In Re: **NO CAPX 2020 COMMENT ON ENVIRONMENTAL ASSESSMENT**
Dairyland Power Cooperative Upgrade of Q-1D South, USDA RUD #1060

Please accept this as a Comment on the RUS Environmental Assessment for this project, made on behalf of No CapX 2020.

Figure 2 - Briggs Road-La Crosse Tap Project One-line

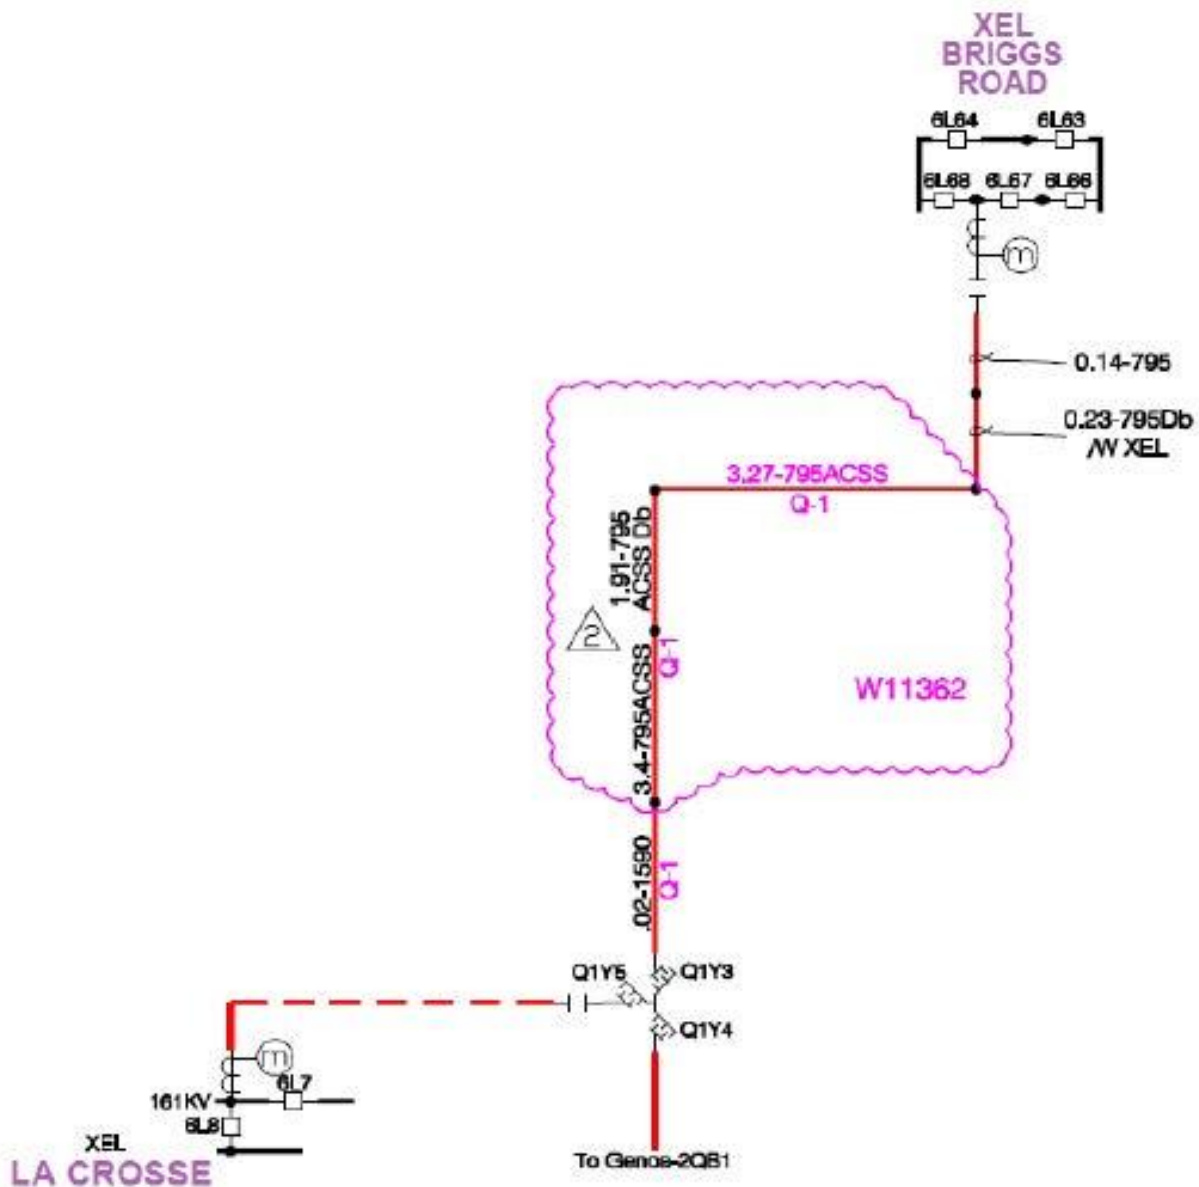
- The conductor size in the EA Table 2-3 is 656 ACCR, and in the same table in the “Study,” labeled “Table 4” it is 795 ACSS, and the one line drawing, Figure 2, reflects the same conductor. This inconsistency should be corrected.
- The one line drawing may explain the earlier statement that the line begins just a bit south of the Briggs Road substation. See “Study,” Figure 3.
- The EA should include the one line drawing from the “Study” with a legend.

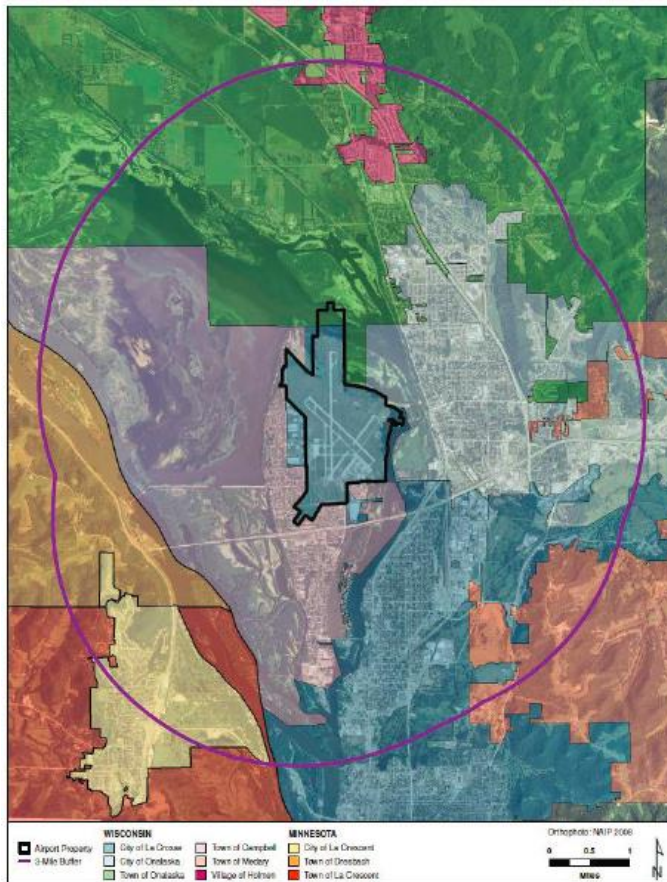
- The EA is inadequate because it does not address homes and businesses within the easement other than Table 3.1 on p. 3-5, which shows that there are 24 residences 40 feet or less from the centerline, and 2 businesses 30 feet or less from the centerline as it exists now. Siting a transmission line this close is unacceptable.
- In another place, the EA states that “[t]here are 42 residences and four businesses located within the 80-foot ROW.” EA, p. 5-1. This is not acceptable.

The EA is inadequate because it does not accurately depict the machinations that Dairyland is going through to change the AOZD. EA p. 3-6. Below is the AOZD map:
